**1 2 3 ALTERATION NUMBER FOR SUBJECT APPLICATION**

PL2	20/10/2021	GS	RL	PK	ISSUED FOR PLANNING ALTERATIONS
Rev	Date	By	CHK	App	Reason
Drawing Title: <b>PLANNING ALTERATIONS</b>					
Job Title: <b>INDUSTRIAL DEVELOPMENT AT TAY LANE, GREENOGUE, RATHCOOLE, Co. DUBLIN</b>					
Drawing Title: <b>BLOCK A - LIGHT INDUSTRIAL UNIT &amp; ANCILLARY OFFICE/STAFF FACILITIES SECTIONS</b>					
Author/Dept: <b>ELECTRICAL WASTE MANAGEMENT LTD.</b>					
Consulting Engineers: <b>KAVANAGH BURKE CONSULTING ENGINEERS</b>					
Tel: 01-450 0694		Unit F3, Calmount Pk.		Ballymount, Dublin 12.	
Fax: 01-426 4340		Email: pkavanagh@kavanaghburke.ie			
On: GS	Checked: RL	Approved: PK			
Scale: 1:100 (B/A1)	Date: NOVEMBER 2021				
Job No: D1541	Drawing No: GA-A-A03	Rev: PL2

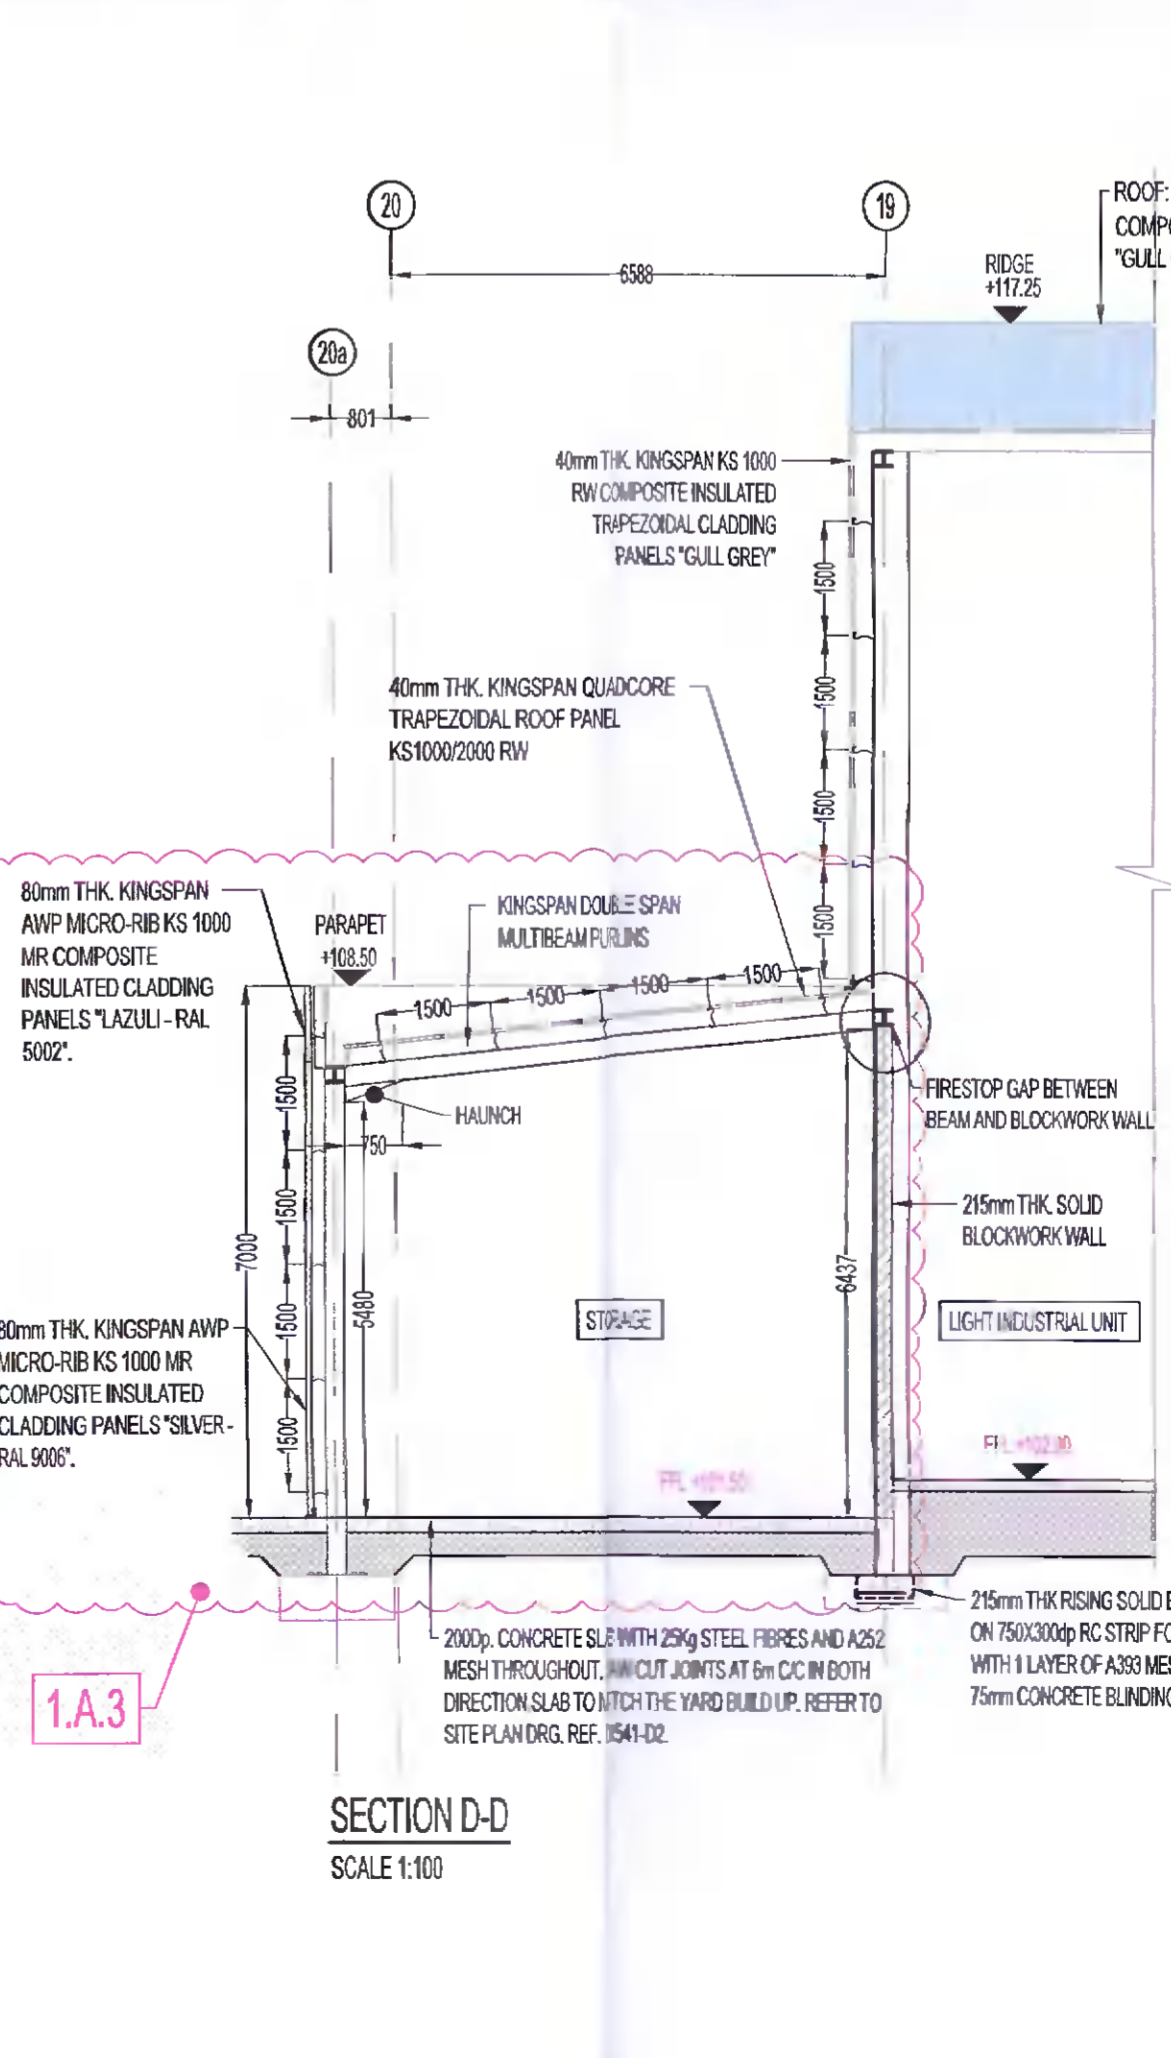
- RECONFIGURATION OF THE FLOOR PLAN AREAS AS FOLLOWS:**
  - A. Provision of 535m<sup>2</sup> additional floor area due to introduction of areas as follows:

- A.1. Extended display area at ground floor of ancillary Office, addition of 42m<sup>2</sup> floor area;
    - A.2. Extended open plan office at first floor of ancillary office, addition of 22m<sup>2</sup> floor area;

- A.3. Single storey ancillary storage facility to the front north-east elevation, totalling 166m<sup>2</sup>, overall height 7m;
    - A.4. Mezzanine area to the south eastern side of Light Industrial Unit, totalling 303m<sup>2</sup>;
 Alterations listed above result in total building area increase from 4361m<sup>2</sup> to 4926m<sup>2</sup>, as shown at the revised table of gross internal floor areas & uses.

- B. Change of use of 64m<sup>2</sup> of Light Ind. Unit floor area to staff facilities due to the introduction of:
    - B.1. Enclosed stairs from Light Industrial Unit to ancillary Office/Staff facilities (overall 31m<sup>2</sup>);

- B.2. Single storey cleaners store and storage at ground floor to the north-eastern corner of Light Industrial Unit (overall 33m<sup>2</sup>);
  - C. Change of use of 100m<sup>2</sup> of workshop charging area & staff facilities to workshop area & single storey office/staff facilities;

- D. Introduction of full height dividing wall at Light Industrial Unit.
- ELEVATIONS ALTERATIONS AS PER LIST ABOVE PLUS ADDITIONAL ALTERATIONS AS FOLLOWS:**

- A. Provision of full height cladding (ground floor to roof) to Light Industrial Unit and ancillary Workshop;
  - B. Introduction of 11m wide x 6m high open to Light Industrial Unit side (north-western) elevation;

- C. Rearrangement of all fire exit & level access doors to Light Industrial Unit & ancillary Workshop, including omission and addition of the same;
  - D. Introduction of integrated modular louvre system to Light Industrial Unit rear (south-western) & side (north-western) elevation;

- E. Introduction of canopies to the ancillary Office main entrance and above 11m wide open & dock levelers to Light Industrial Unit side (north-western) elevation.
